Notice of Citizen's Appeal of  
Los Padres National Forest Oil and Gas Leasing  
Record of Decision and Final Environmental Impact Statement

**LOS PADRES  
FORESTWATCH**

**September 15, 2005**

FIGURE 2

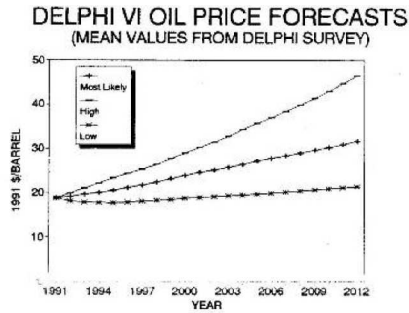
Although the RFD correctly identifies the price of oil as the first "key factor" influencing the rate of oil and gas exploration on the LPNF, the accuracy of its analysis ends there. Bain 1993, pp. 18-19. Demonstrating the profoundly outdated nature of the analysis provided by the Bain report, it predicts \$27 per barrel (in 1991 dollars) as the "most likely" oil price for 2005.

Adjusting for inflation, the “most likely” oil price in 2005 dollars is \$38.74 per barrel.<sup>1</sup> This is radically lower than today’s actual oil prices, which have steadily hovered over \$60 per barrel, greatly exceeding even the graph’s “high” maximum oil price forecast.
